Campaign Service

CB20-N-004A

IMPORTANT SAFETY RECALL

POSITIVE BATTERY CABLE ADJUSTMENT – 20V-720

Figure 5

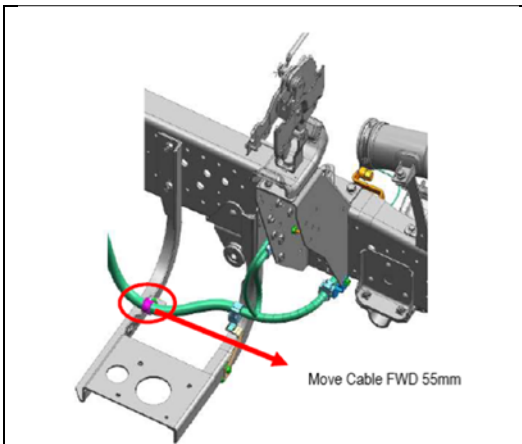
- Move the positive battery cable harness forward (toward the front of the vehicle) 55mm. (See Figure 5.) The “P” clamp should now be located 55mm rearward of the white tape on the positive battery cable harness. (See Figure 6.)

Figure 6

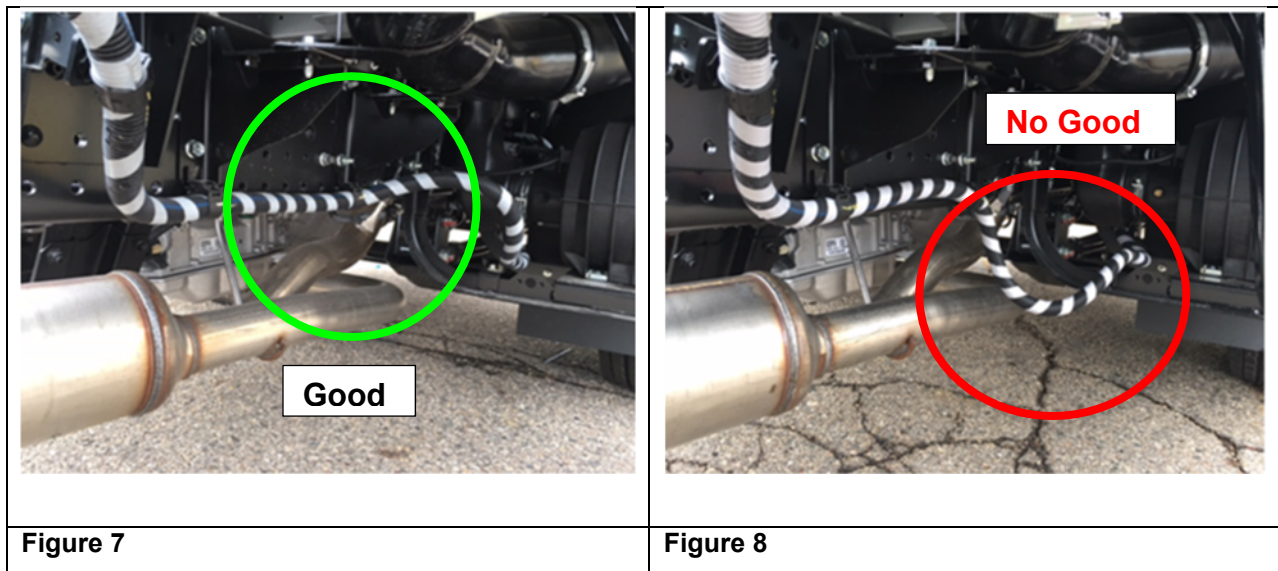
5. Squeeze the “P” clamp tight when the positive battery harness is forward 55mm. Install the “P” clamp hold down bolt and tighten to 10 Nm (7 ft.lb.).

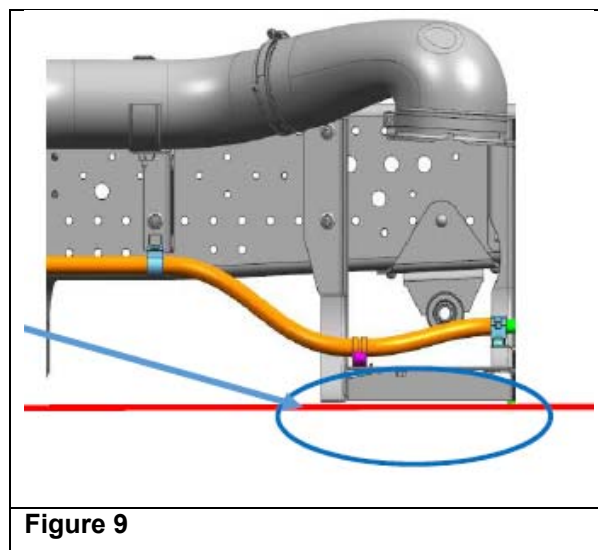
6. Check to confirm the positive battery cable does not hang lower than the air cleaner mounting bracket. (See Figure 9.) Loosen the “P” clamp and adjust if necessary.
